Interactive comment on “World Calibration Center for SF₆ – supporting the quality system of the global atmosphere observation” by J. Lee et al.

Received and published: 21 January 2013

Fig. 1.

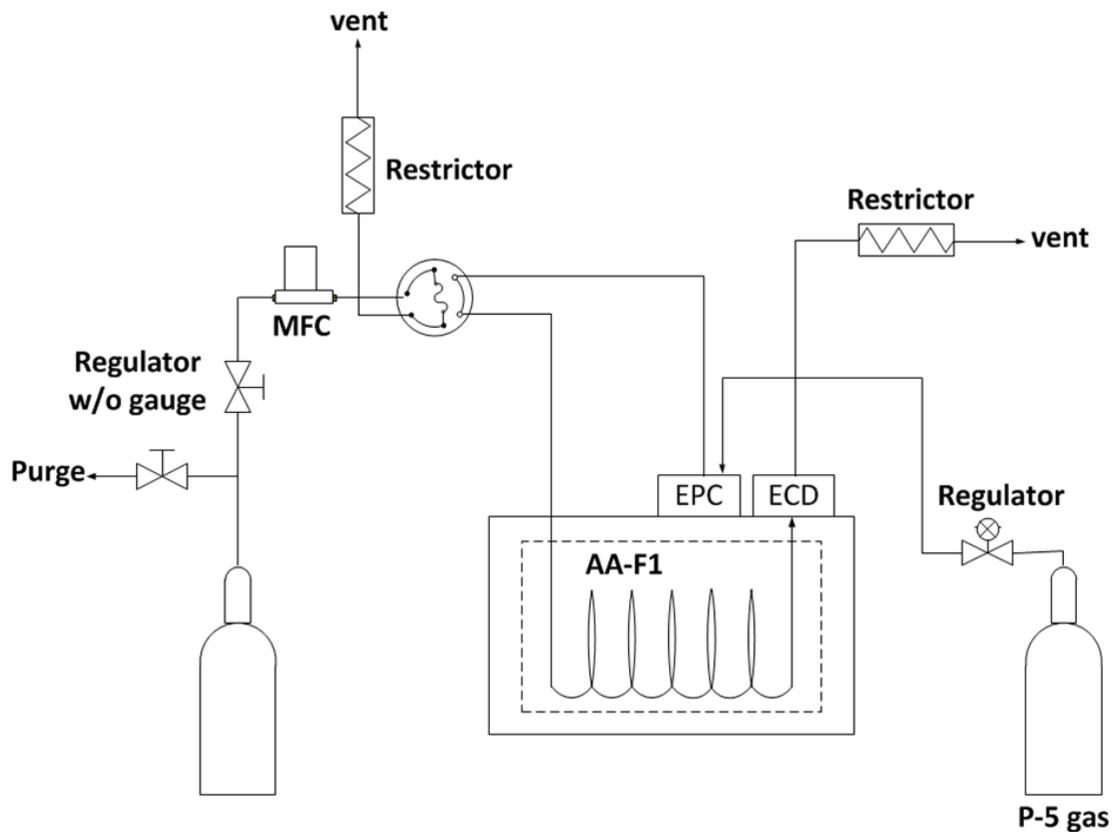
3) restrictor was installed at the ends of vent lines to keep the constant pressure (see the attached Fig. S1) 4) Dead volume along the sample feeding line was significantly reduced.

P7916, Fig. 1: This figure is not mentioned in the text (as already noted above). Design/colour: The text in the blue box (top left) is hard to read. Mind the contrast of

colours. Replace “Roundrobin” with Round-robin”. Caption: Replace “CCL” with “CCL”.

=> This figure will be mentioned in the text and redrawn as suggested. (Fig. S2)

Fig. 2.

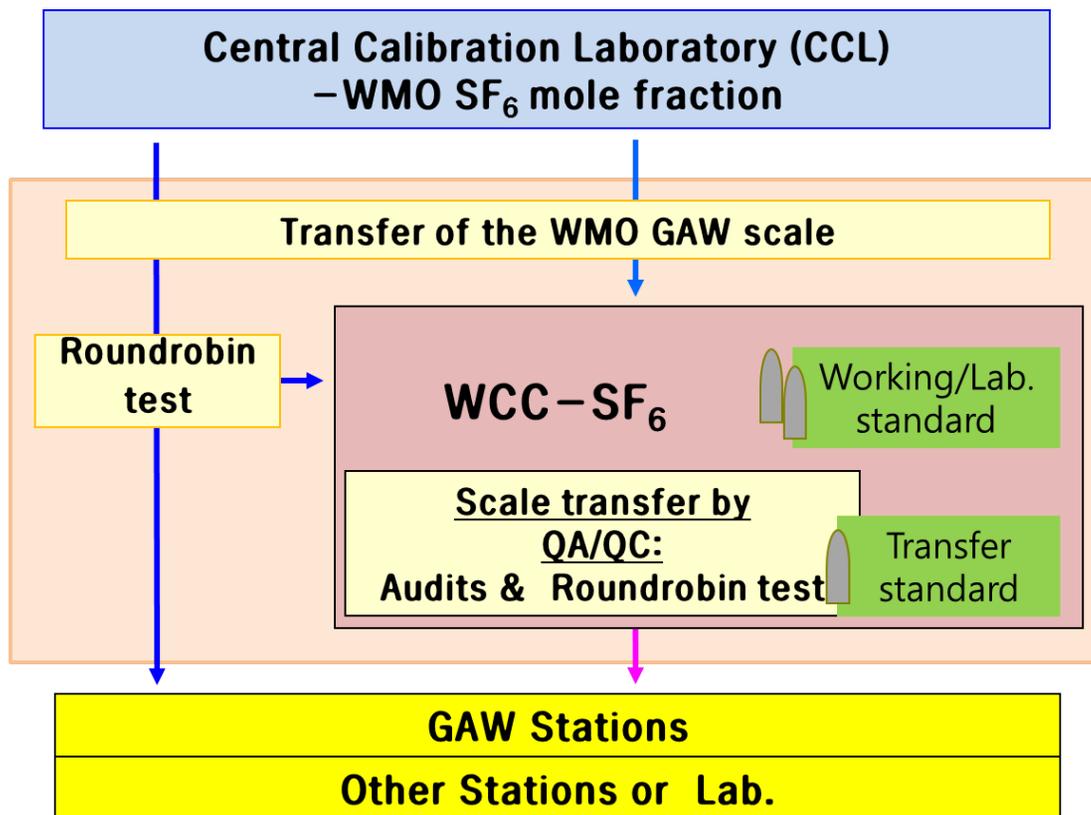
P7917, Fig. 2: Font size on axes: Suggestion to enlarge as shown in Fig. 4. “Heater” obviously means “ECD”. Replace “PP-Q” with “Porapak-Q”. Give length of the Activated alumina-F1 column. The number for the flow is different from the one given in the main text. Use uniform unit for volume (ml or cc). Caption: Replace “. . .column selection installed at. . .” with “type of column installed in the GC”. Caption: Typo, replace “minites” with “minutes”

Fig. S2 Traceability chain of SF6 through the CCL and GAW stations

=> Figure will be enlarged as much as possible. And caption will be corrected as suggested.
